STATE OF MAINE
 DEPARTMENT OF TRANSPORTATION
 16 STATE HOUSE STATION
 AUGUSTA, MAINE
 04333-0016

April 15, 2009
 Subject: **Portland**
 Federal Project No. BH-1015(800)S
 State Pin No. 010158.00
Amendment No. 1

STATE OF MAINE DEPARTMENT OF TRANSPORTATION	BH-1015(800)X PIN	BRIDGE NO. 5052 010158.00
VERANDA STREET OVERPASS ST. LAWRENCE & ATLANTIC R.R. PORTLAND CUMBERLAND COUNTY	PRECAST VOIDED SLAB 2 & 12	
PROJ. MANAGER J. WENTWORTH TEAM S. CHECKED-REVIEWED DESIGN-DETAILED	DATE	DATE
REVISIONS 1 DESIGNS-DETAILED	REVISIONS 2 STAND DESIGNATION	REVISIONS 3 REVISIONS 4 FIELD CHANGES
SIGNATURE	P.E. NUMBER	DATE

30

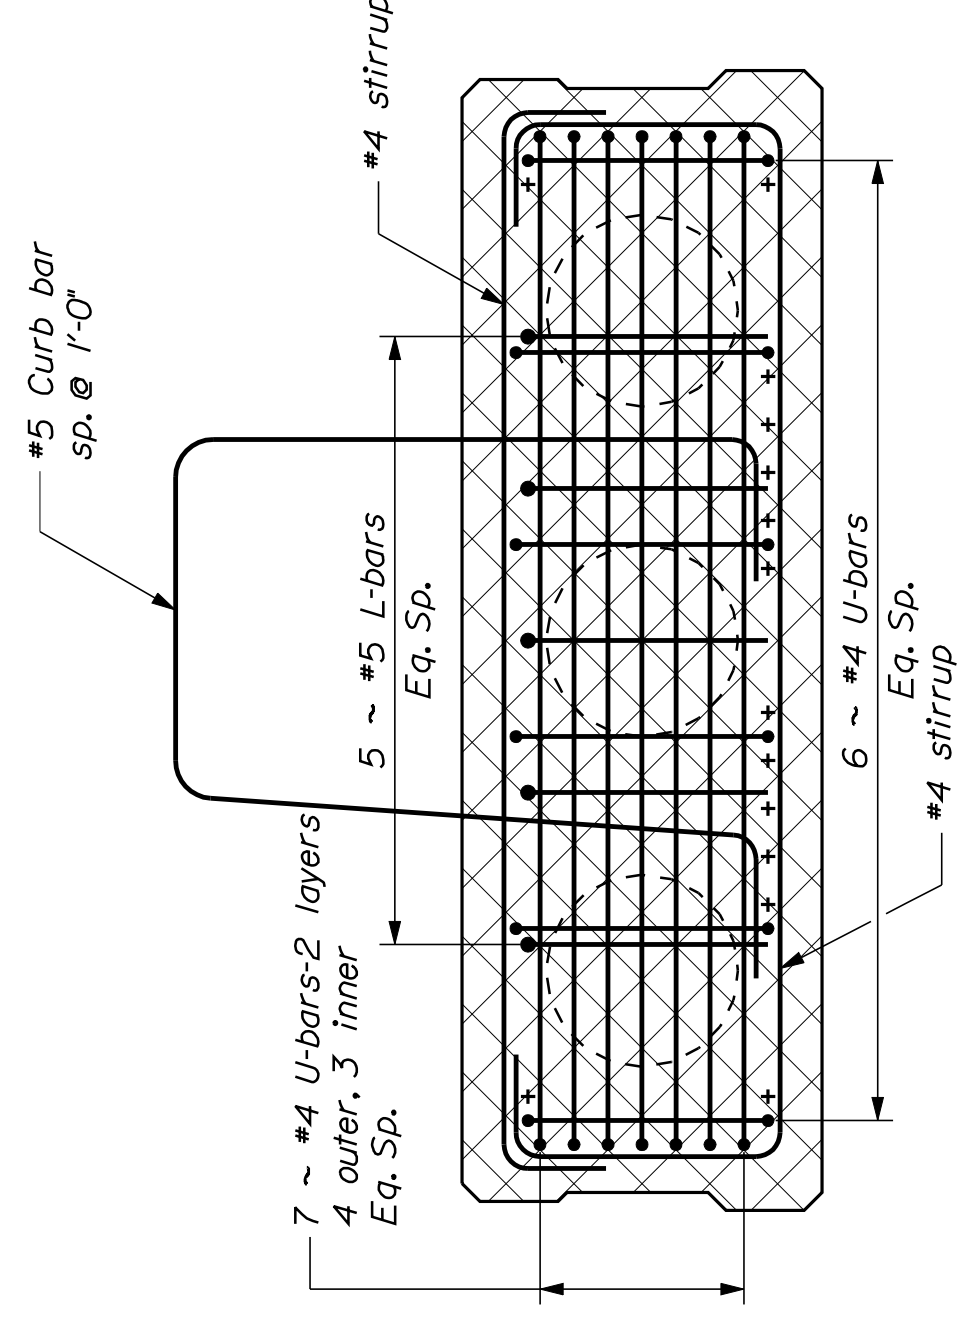
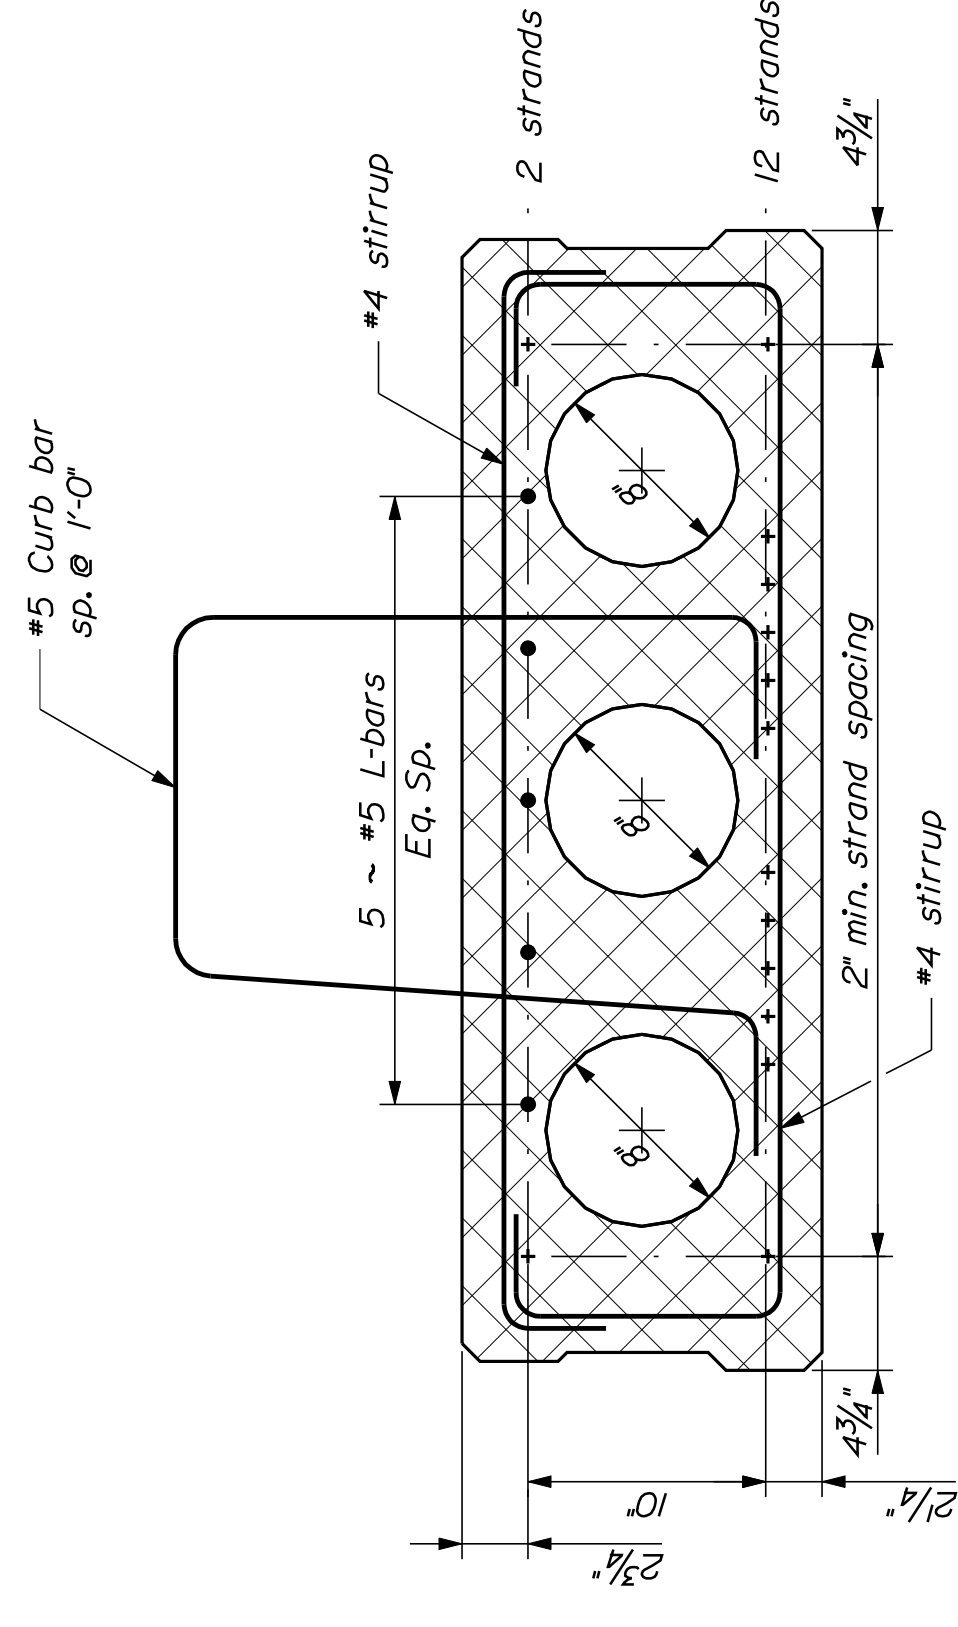
In the Plans, **REMOVE** Plans Sheets 29 of 38, 30 of 38 and 31 of 38 and **REPLACE** with the attached new Plan Sheets 29 of 38, 30 of 38 and 31 of 38 revised on 04-13-09.

PROJ. MANAGER	J. WENTWORTH	BY	DATE
DESIGN-DETAILER	R. NAOUS	TEAM	S.
CHECKED-REVIEWED			
DESIGN-DETAILED			
REVISIONS 1	note & strand designation	04-13-09	P.E. NUMBER
REVISIONS 2			
REVISIONS 3			
REVISIONS 4			
FIELD CHANGES
